Appendix 4: Internal Referral Responses

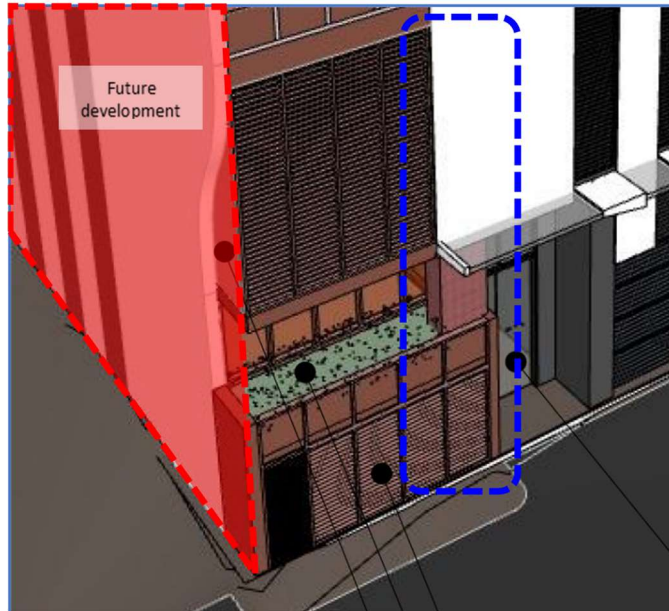
- 3. The Mezzanine level activation at the Gladstone Place frontage is supported. The effectiveness of the southern façade treatment (cutaway), however, will be limited by future development on the abutting site that will likely be built to the northern and laneway boundaries (refer to diagram below – red shading). It is recommended that the cutaway façade treatment be relocated to the interface between the Mezzanine Retail / Communal area and the Rear Entry & Bike Access (blue dashed outline in diagram below). This change could be conditioned.
